DEPARTMENT OF THE NAVY  
CRANE DIVISION  
NAVAL SURFACE WARFARE CENTER  
CRANE, INDIANA 47522-5000

Re: Contract No. N62472-90-D-1298 "CLEAN"  
Risk Assessment Work Plan  
CTO #0076, NAVSURFWARCENDIV, Crane, Indiana  
RUST E&I Project No. 20615

The United States Environmental Protection Agency (U.S. EPA) has reviewed the Risk Assessment Work Plan for Solid Waste Management Units #03/10, #06/09, and #07/09, dated June 1993. Our detailed comments are enclosed.

COMMENTS ON THE  
RISK ASSESSMENT WORK PLAN  
FOR  
SOLID WASTE MANAGEMENT UNITS 03/10, 06/09, AND 07/09  
NAVAL SURFACE WARFARE CENTER  
CRANE, INDIANA

**Figure 4 - 1**  
**Scenario A**  
 (Current OB/OD Activities Cease; Area Remains a Naval Base)

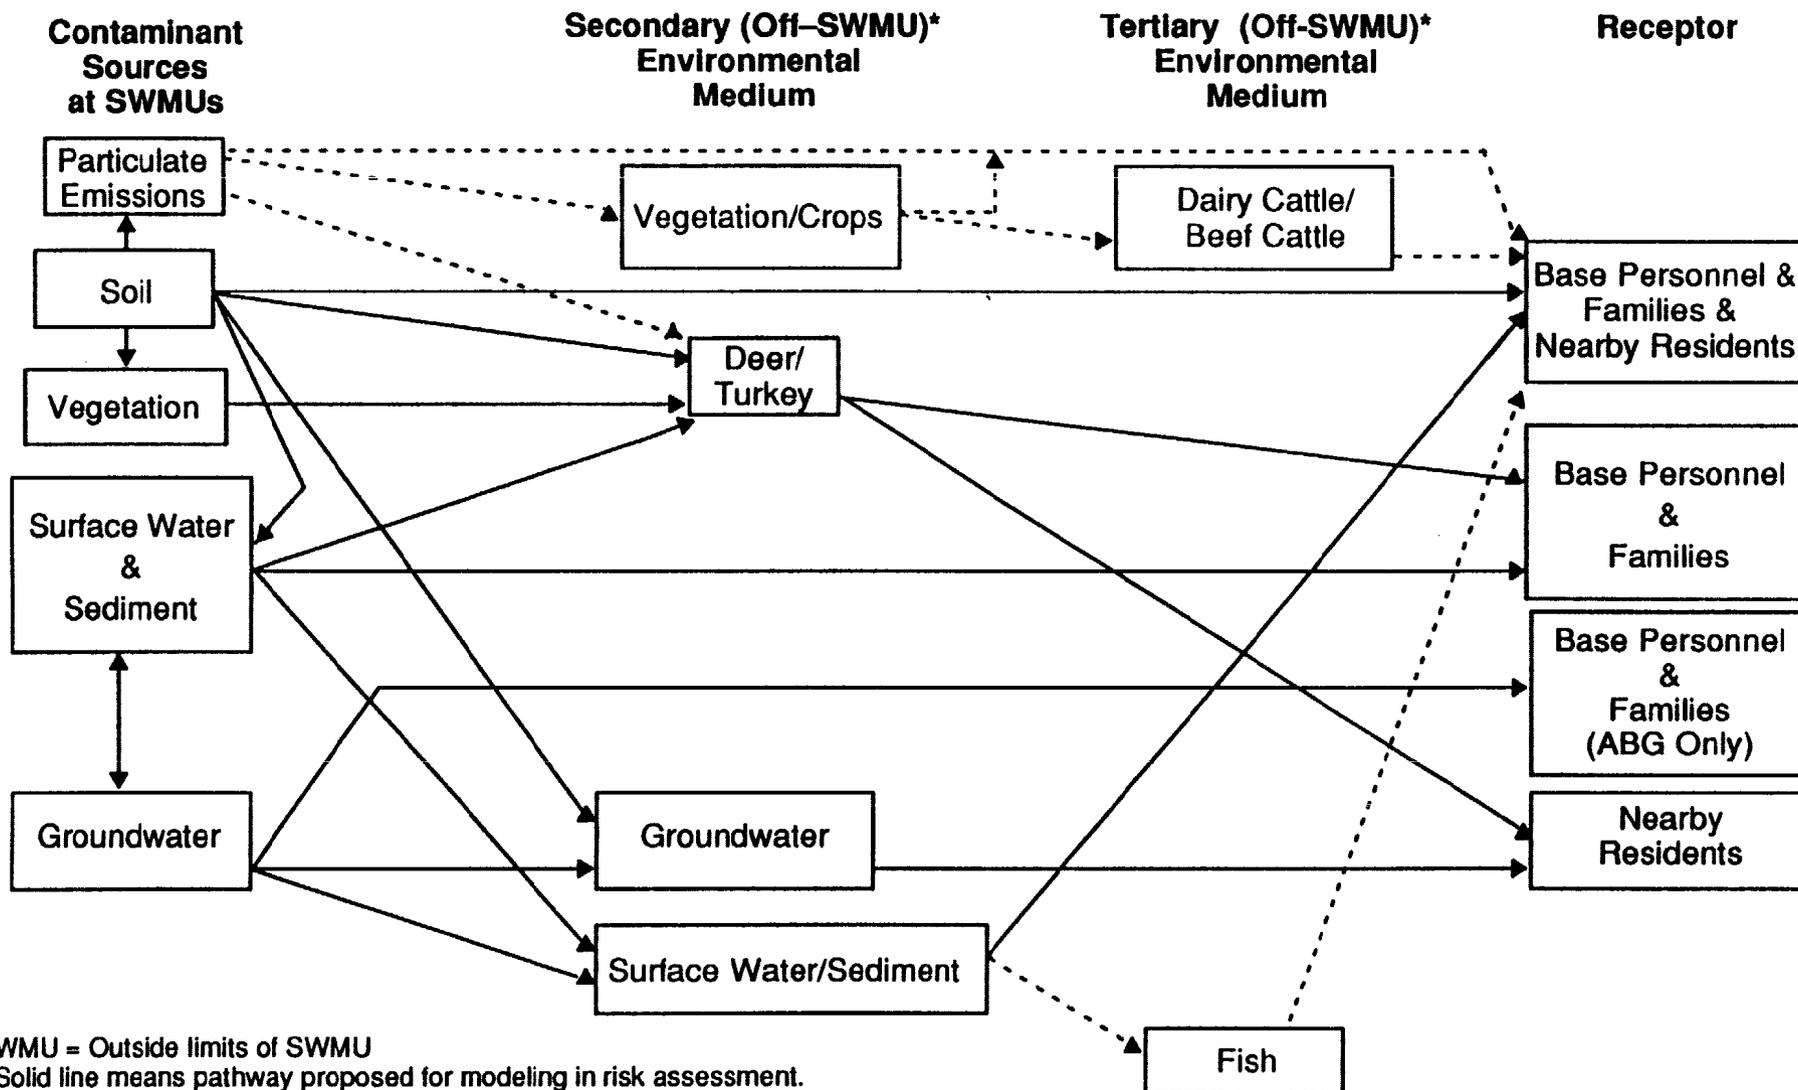
RTC16(j)(2): The line between Deer/Turkey and Base Personnel and Families should be solid, and this change has been made in Figures 4-1 and 4-2 (attached).

RTC16(j)(3): Solid lines have been added connecting Soil and Groundwater and connecting Soil and Surface Water and Sediment in Figures 4-1, 4-2, and 4-3 (attached).

Figure 8-1

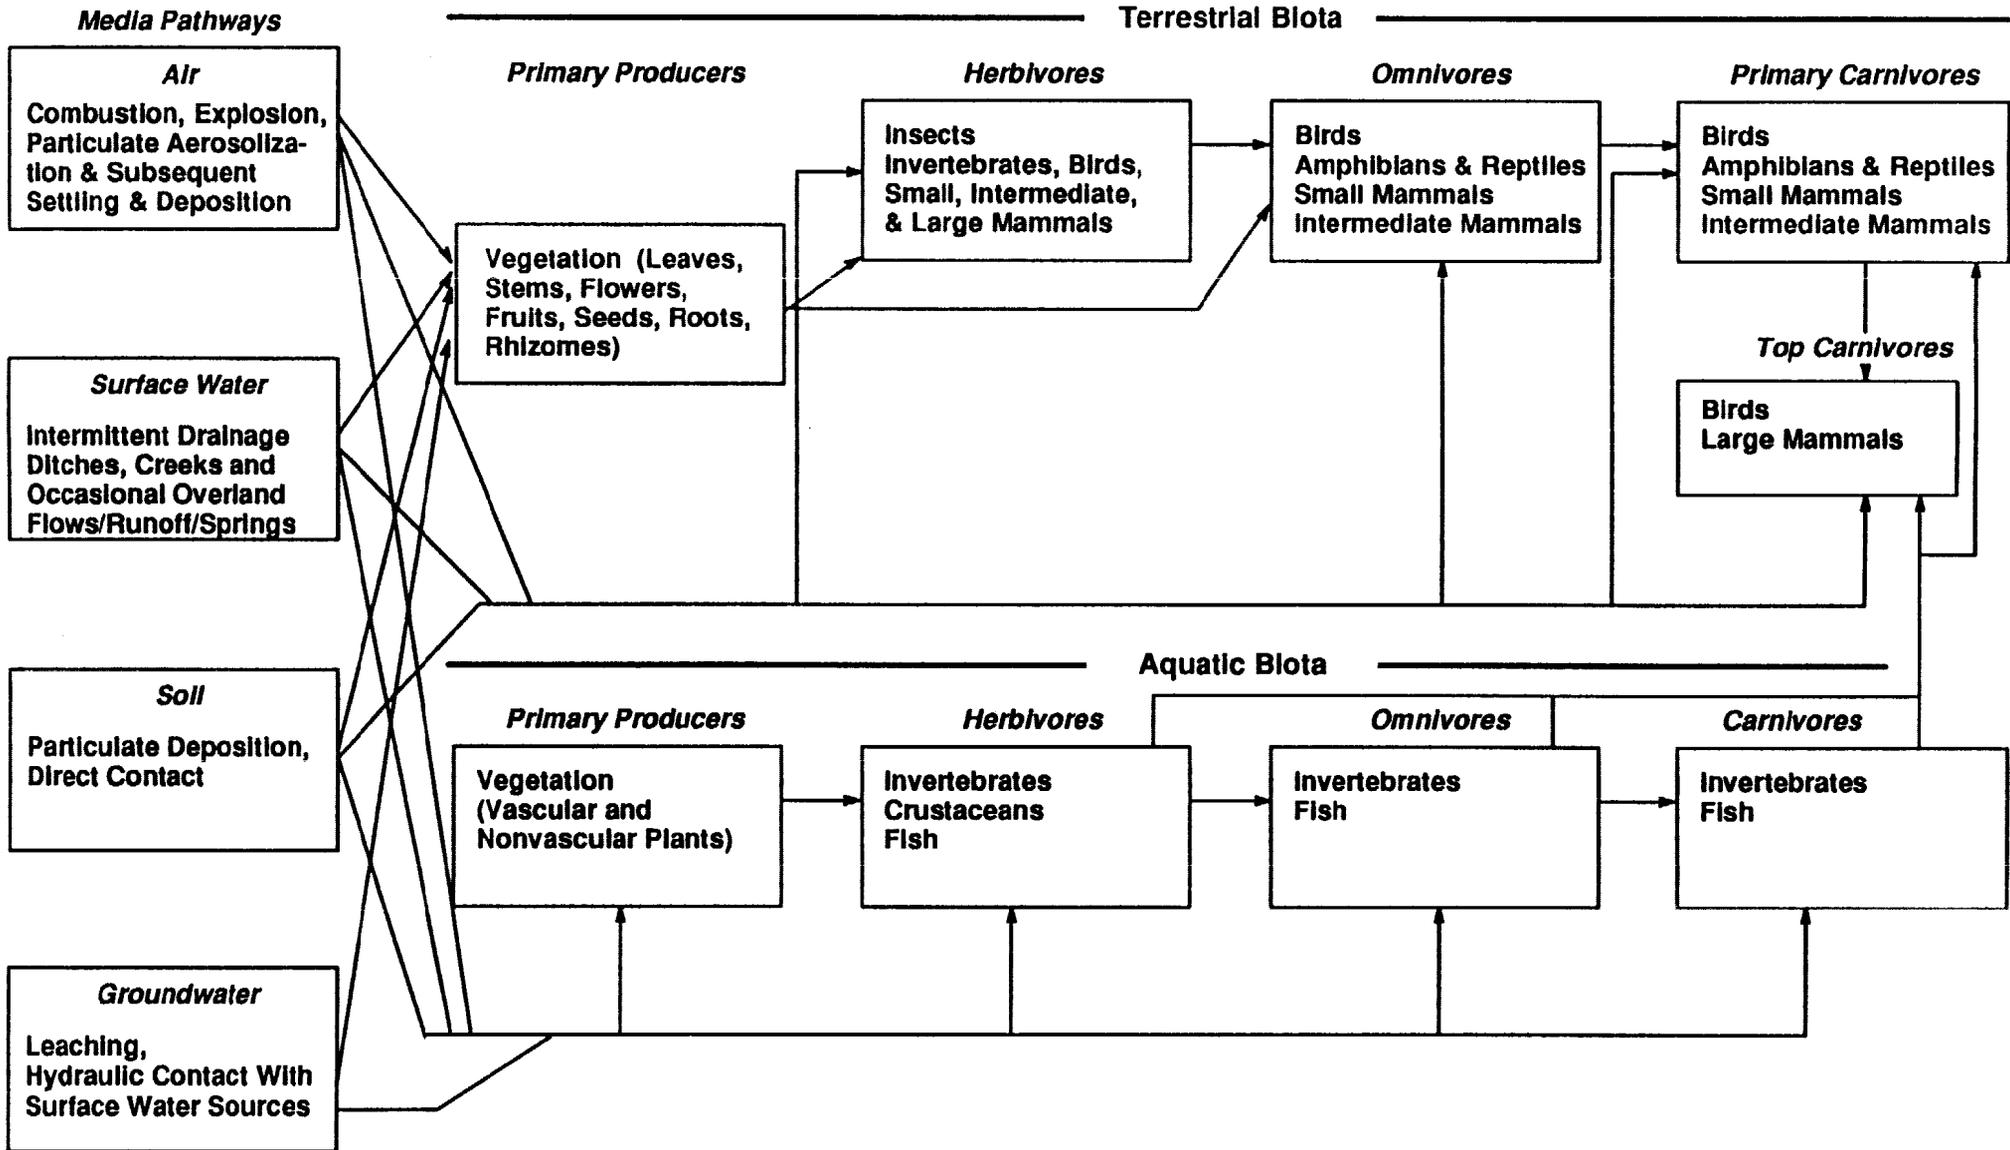
- a. Add in springs specifically, not just as a creek.
- b. Run-off is a surface water issue not a ground water one.
- c. Change the weak link from ground water to vegetation to a strong link.
- d. Since the conceptual models are identical for each scenario, only two figures should be presented, i.e., one current and one future conceptual model.
- e. The conceptual models are too busy, i.e., extraneous and ecologically insignificant information should be excluded and the ecologically most significant pathways should be highlighted.
- f. The future use scenario ignores the wind-borne soil exposure pathway.

- RTC36(general): Figures 8-1, 8-2, 8-3, and 8-4 in the draft RAWP have been consolidated into Figures 8-1 and 8-2 (attached).
- RTC36(a): Comment noted. Discussion was held during the August 12, 1994, telephone conference call concerning this issue. At the time of the preparation of the RAWP it was unclear based on available hydrologic information as to whether a clear solid hydraulic conductivity relationship could be established for the springs near the three SWMU sites. After the discussion, it was agreed to include the springs as a potential surface water source of contamination by designation. The figures will be altered to reflect this change.

- RTC36(b): The comment is noted and we concur. Run-off will be included as a surface water condition and not a ground water one.
- RTC36(c): Comment noted and in much the same manner as described in RTC36a above, at the time of the initial submittal of the RAWP it was not clear that a strong linkage existed between the ground water and the riparian vegetation. We will alter the figure to reflect our recent discussions concerning this matter. At the time of the original submittal, we considered "phreatic water" (near surface ground water) to be more a surface water condition than a ground water condition.

**RTC36(g):** The comment has been noted. A revised figure will be prepared as part of the RTC36d cited above. This figure will clearly identify the ingestion, inhalation, and dermal contact exposure routes.

**RTC36(h):** This comment has been noted. A revision to the food chain portion of the figure will be made to illustrate the path from fish to piscivorous birds and from fish to mammals as requested by the USEPA for the ERA.
